MPC107 Revision 1.3 and 1.4: Comparison and Compatibility

This document describes electrical and functional differences between Rev 1.3 and Rev 1.4 of the MPC107 PCI Bridge/Memory Controller, which provides a bridge between the Peripheral Component Interconnect (PCI) bus and the MPC603e, MPC740, MPC750, MPC745, MPC755, MPC7400 and MPC7410 PowerPC™ host processors.

AN2455 Rev 0.1

Figure 1. Rev 1.3 and Rev 1.4 $\overline{DBGn}$ Signal Timing

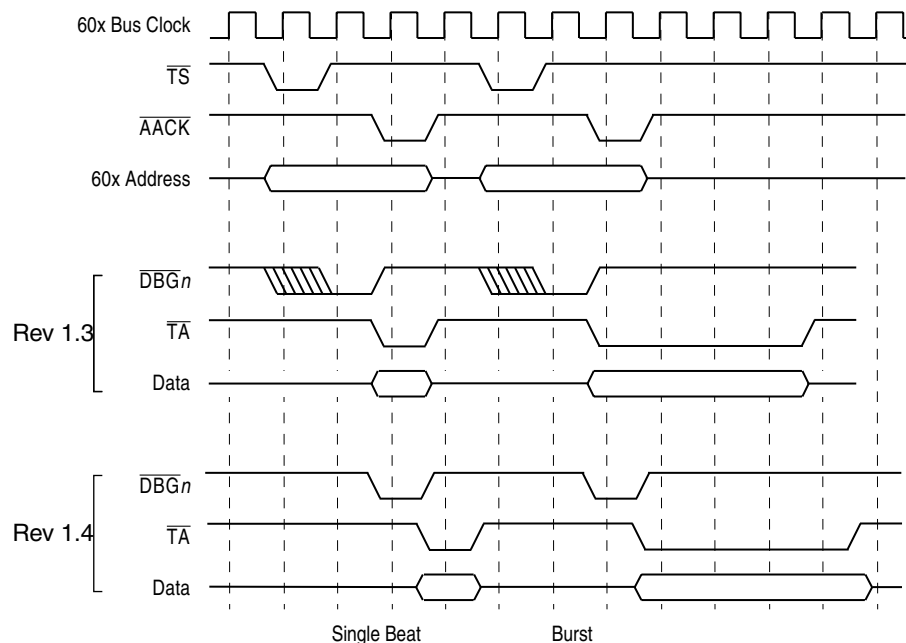
As described in Section 3.2, “MPC7450 Compatibility,” to guarantee that $\overline{TA}$ is not asserted on or before $\overline{AACK}$, the timings for $\overline{DBGn}$ and $\overline{DBGLB}$ were changed in Rev 1.4 to fix the MPC7450-compatibility problem. Before Rev 1.4, the MPC107 may drive $\overline{DBGn}$ (and $\overline{DBGLB}$) as early as the cycle in which $\overline{TS}$ is asserted. Figure 1 shows the signal timing for $\overline{DBGn}$ and $\overline{DBGLB}$ on Rev 1.3 and Rev 1.4 devices.

For Rev 1.4 of the MPC107, $\overline{DBGn}$ is asserted coincident with $\overline{AACK}$. If a Rev 1.3 system design incorporates external logic that depends on the timing of $\overline{DBGn}$ or $\overline{DBGLB}$, the external logic must be modified to accommodate the altered timing of Rev 1.4.
